67 PP

DA (AMENDED)

67 PP
67 Pacific Parade DEE WHY NSW 2099

**BENSON
McCORMACK
ARCHITECTURE**

DRAWING TITLE
ELEVATIONS - NORTH
ELEVATION

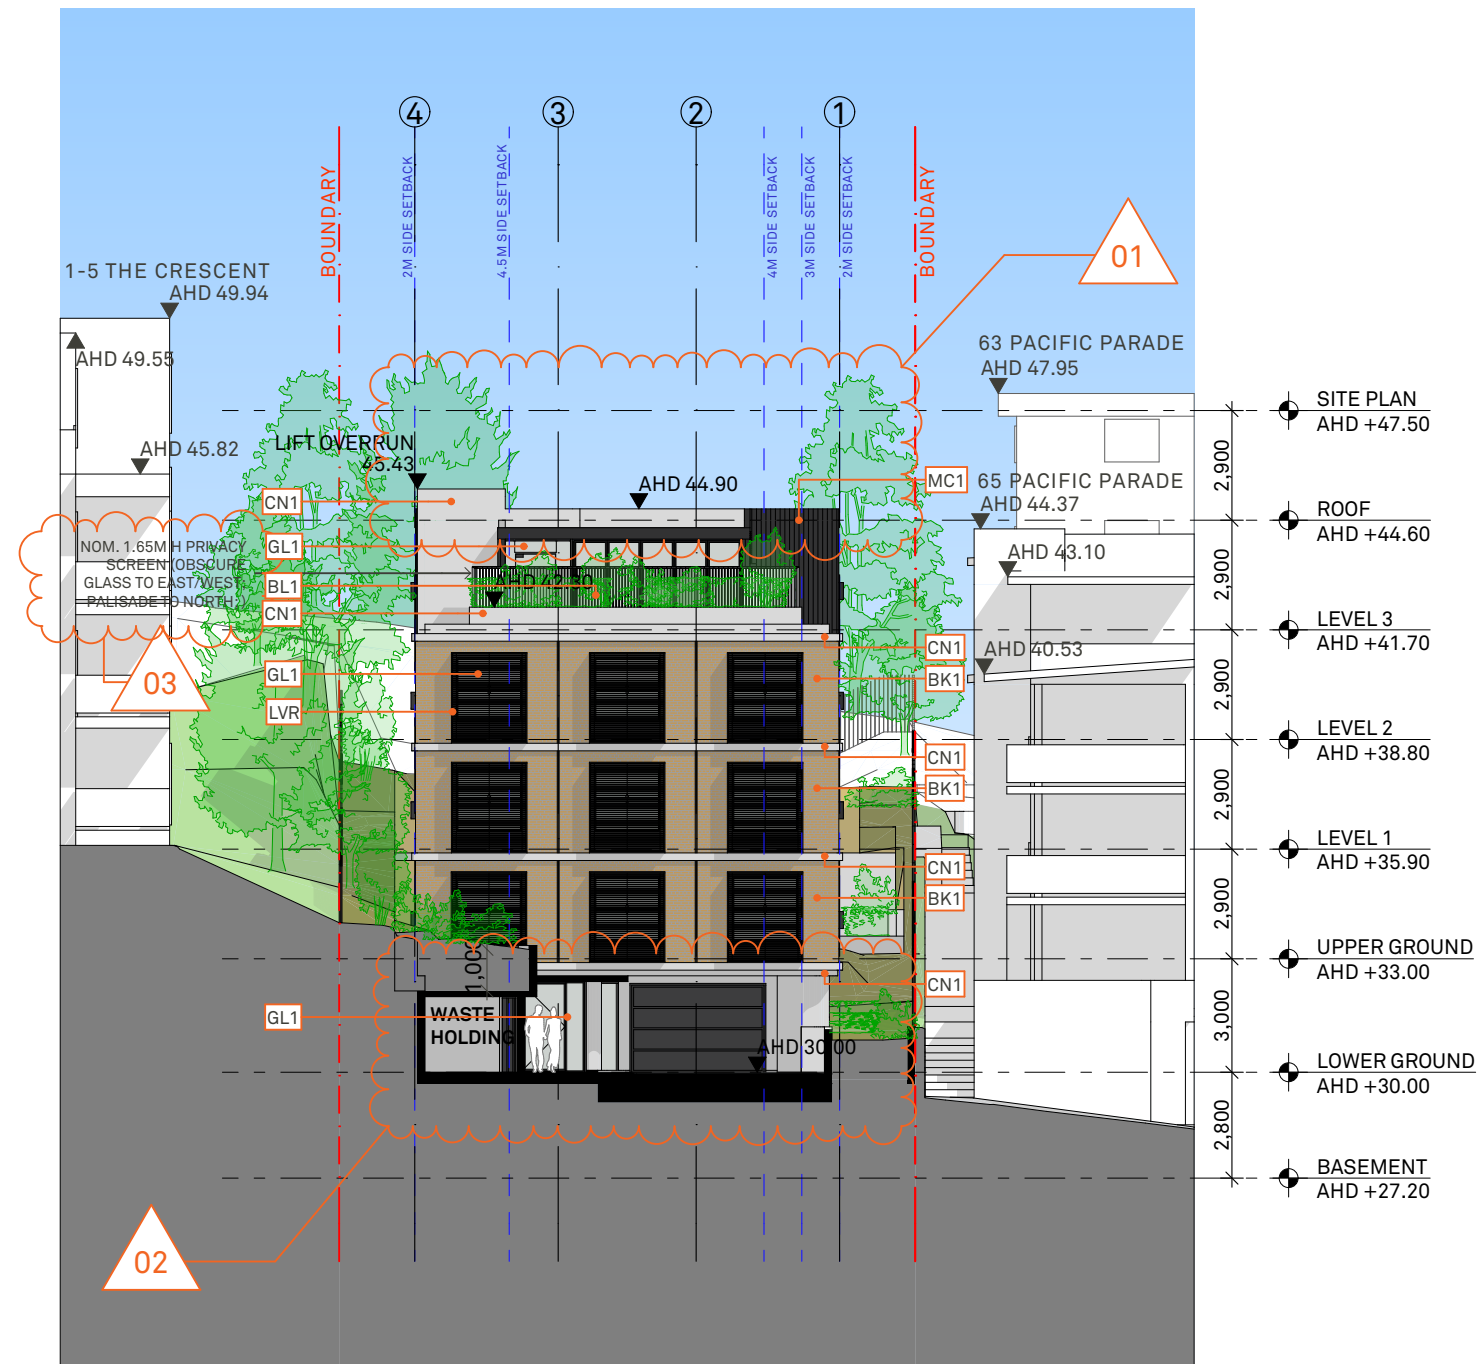
- 01 DELETE LOFT BEDROOMS; REPLACE TYPE E ROOM WITH TYPE B
- 02 REPLACE GARBAGE STORE WITH HOLDING AREA; WIDEN DRIVEWAY; REDUCE GARAGE DOOR WIDTH; INCREASE LANDSCAPED AREA AT THE NW BOUNDARY; INCREASE SOIL DEPTH ABOVE WASTE ROOMS.
- 03 PRIVACY SCREEN TO COMMUNAL OPEN SPACE

DRAWING TITLE
ELEVATIONS - SOUTH
ELEVATION

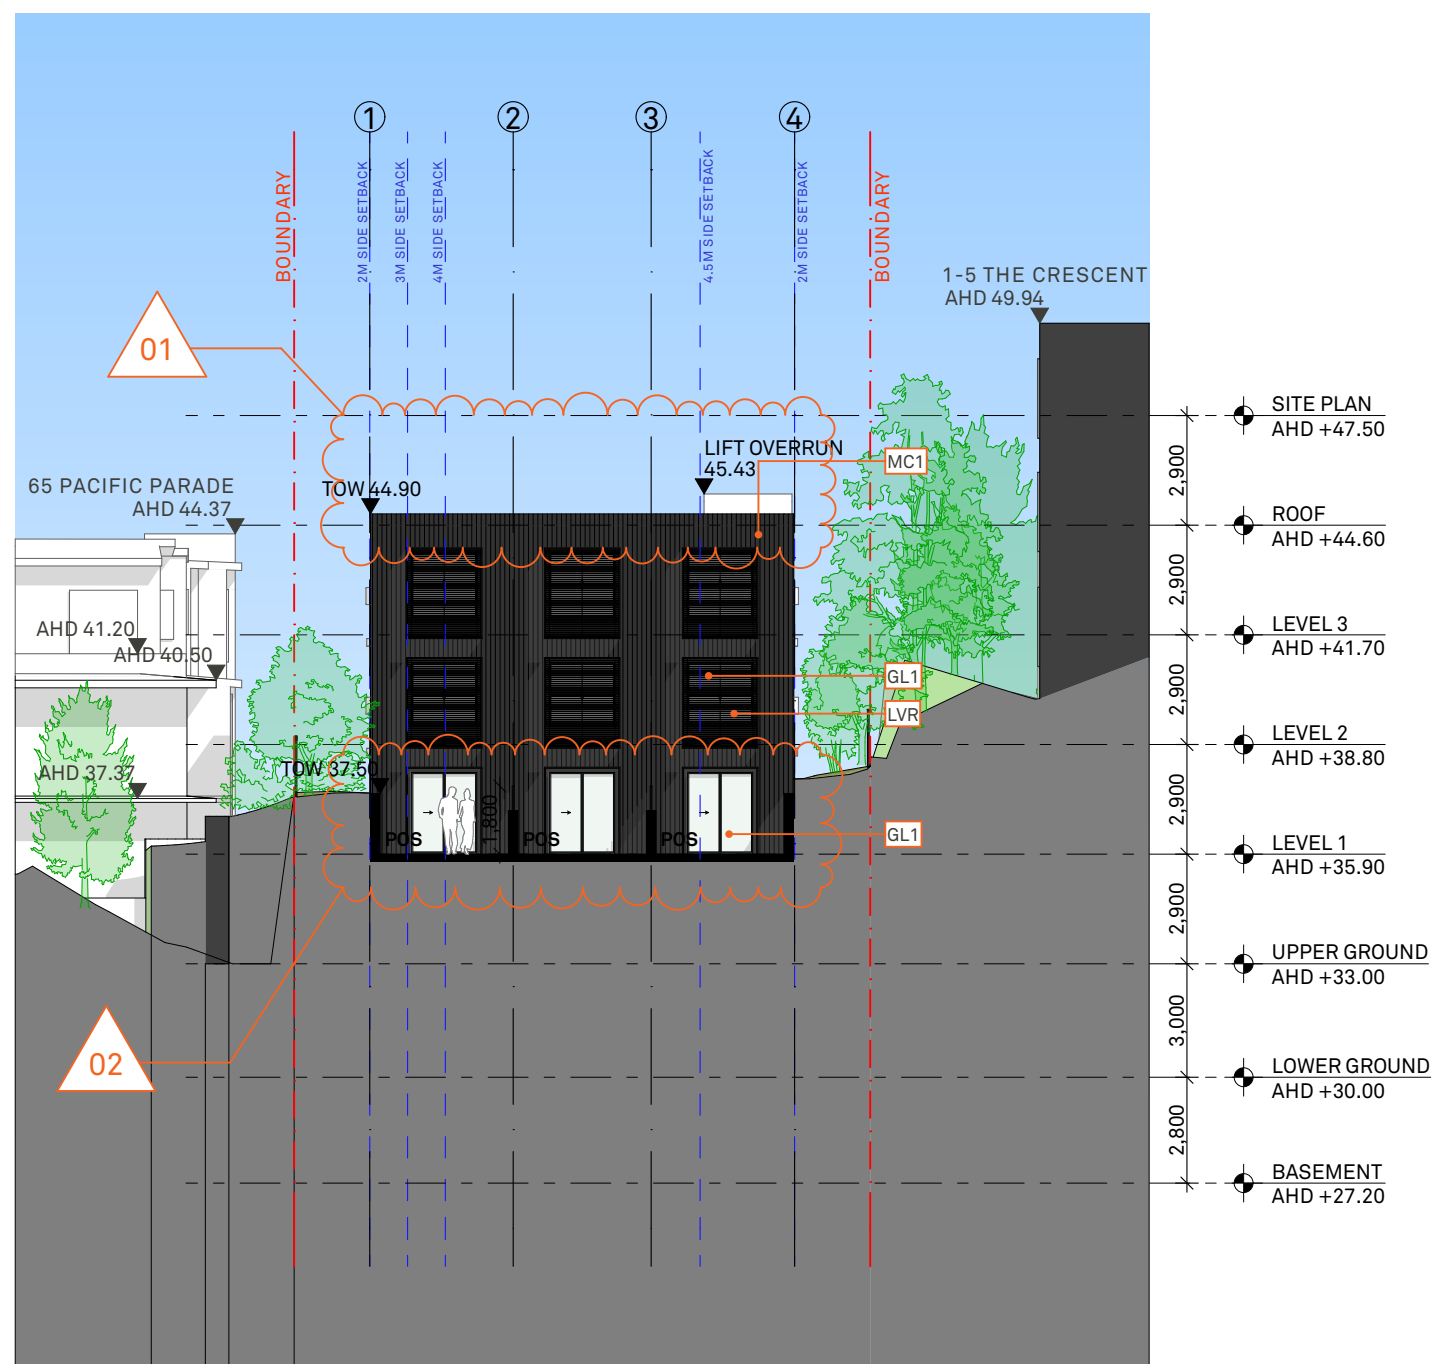
- 01** DELETE LOFT BEDROOMS; REPLACE TYPE E ROOM WITH TYPE B
- 02** REPLACE COMMON ROOM AND COMMUNAL OPEN SPACE WITH 3x ROOMS AND PRIVATE OPEN SPACE

DRAWING TITLE
ELEVATION - WEST
ELEVATION

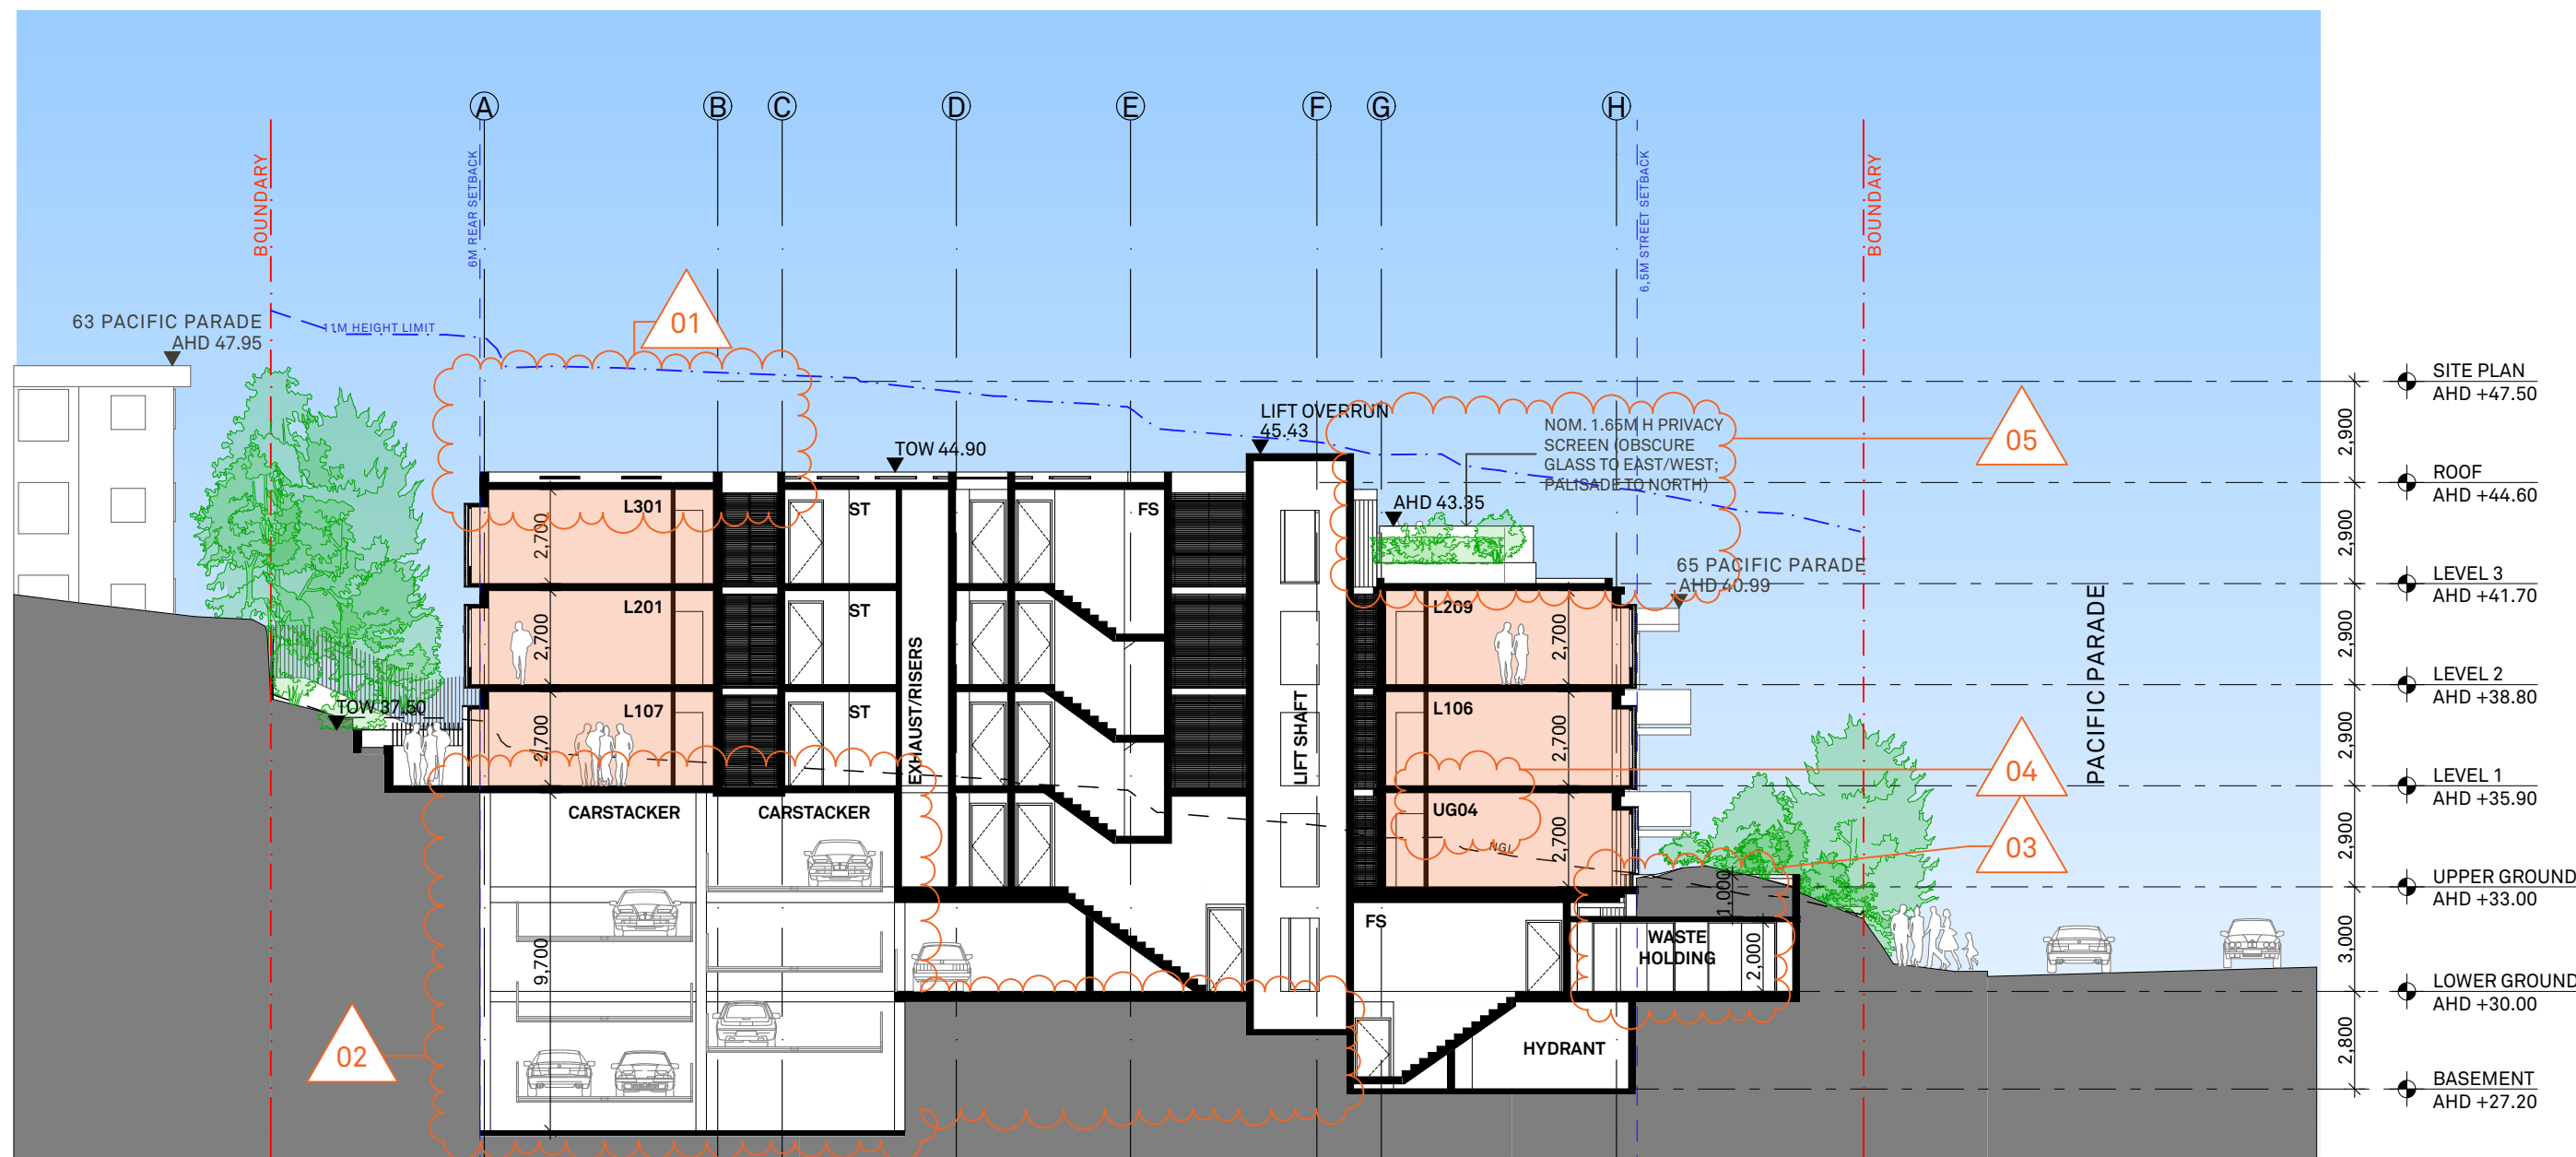
- 01 DELETE LOFT BEDROOMS; REPLACE TYPE E ROOM WITH TYPE B; REMOVE 2x ROOMS IN FAVOUR OF ENLARGED COMMON ROOM AND COMMUNAL OPEN SPACE
- 02 REMOVE BASEMENT FLOOR, LOWER LEVEL COMMON ROOM (LWR GRD); INSTALL CAR STACKERS
- 03 REDUCE AREA OF COMMUNAL OPEN SPACE; PRIVACY SCREEN TO COMMUNAL OPEN SPACE

Client	BL 2093 PTY LTD	Project Details	67 PP	Drawing Title	SECTIONS - SECTIONS CC/DD
	PO BOX 1231		67 Pacific Parade		
	MANLY NSW 2095		DEE WHY NSW 2099

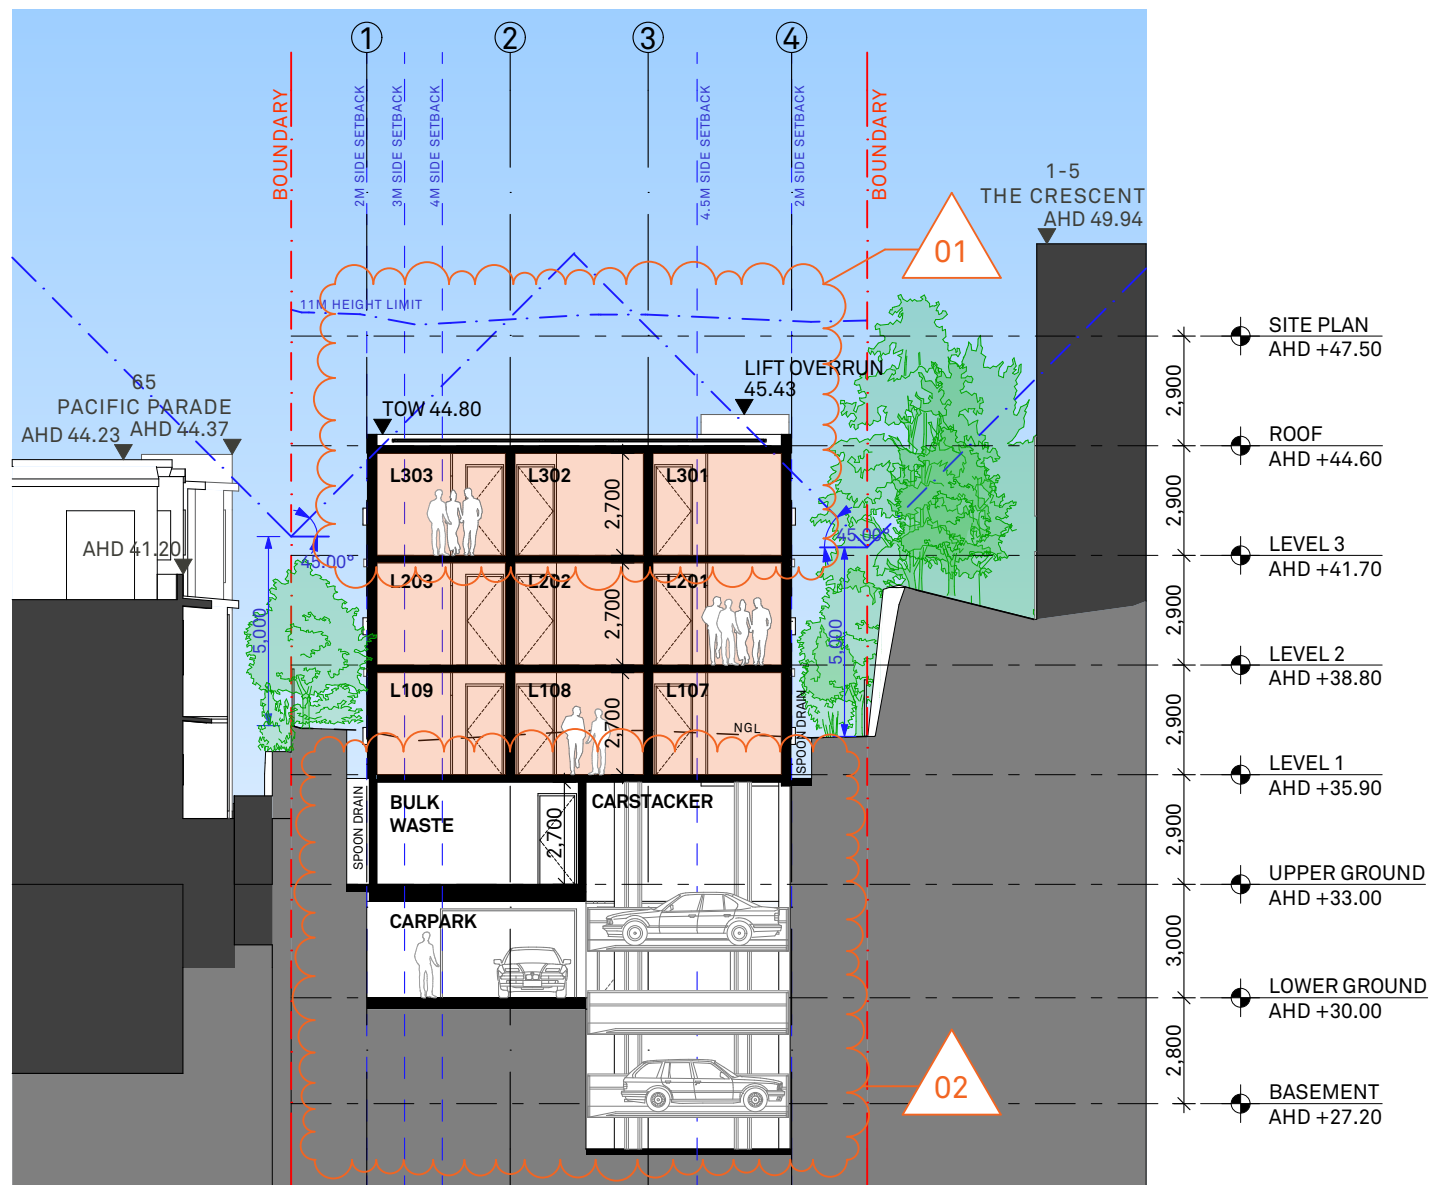
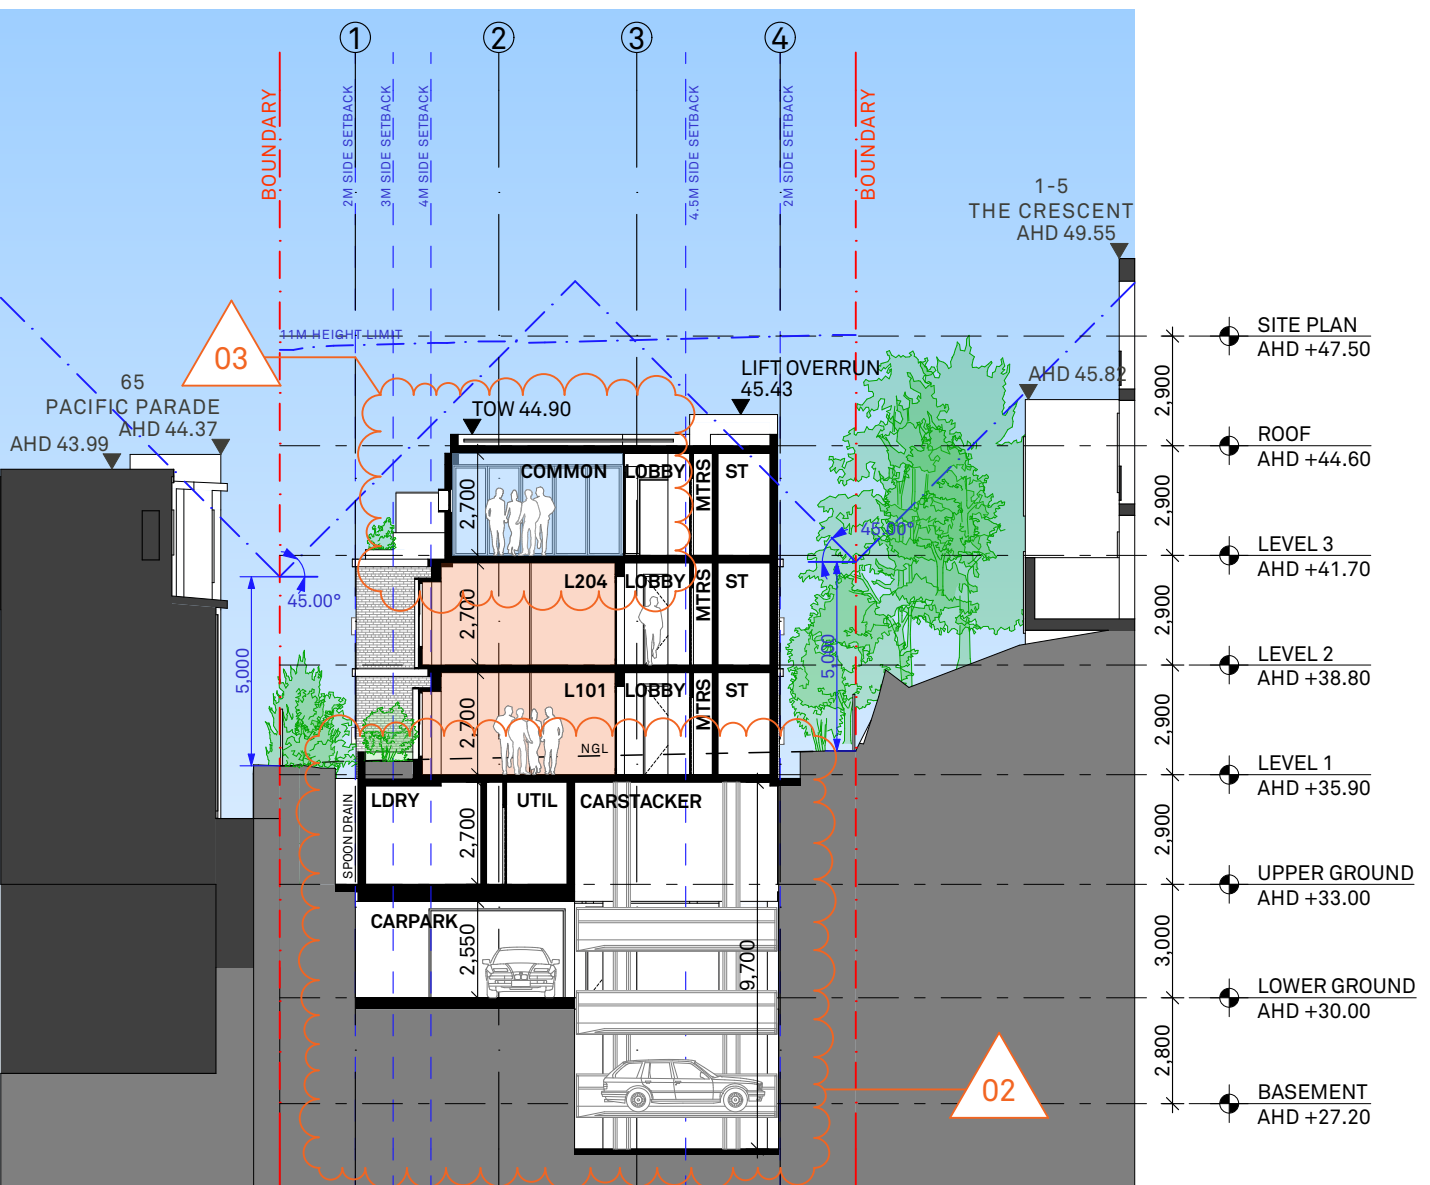
- 01 DELETE LOFT BEDROOMS; REPLACE TYPE E ROOM WITH TYPE B
- 02 REMOVE BASEMENT FLOOR, LOWER LEVEL COMMON ROOM (LWR GRD); INSTALL CAR STACKERS
- 03 REPLACE GARBAGE ROOM WITH BIN HOLDING AREA; INCREASE SOIL DEPTH ABOVE WASTE ROOMS.
- 04 RE-LABEL ROOMS FROM UG05 TO UG04
- 05 REDUCE AREA OF COMMUNAL OPEN SPACE; PRIVACY SCREEN TO COMMUNAL OPEN SPACE

- 01 DELETE LOFT BEDROOMS; REPLACE TYPE E ROOM WITH TYPE B
- 02 REMOVE BASEMENT FLOOR, LOWER LEVEL COMMON ROOM (LWR GRD); INSTALL CAR STACKERS
- 03 INCREASE SIZE OF COMMON ROOM AND COMMUNAL OPEN SPACE
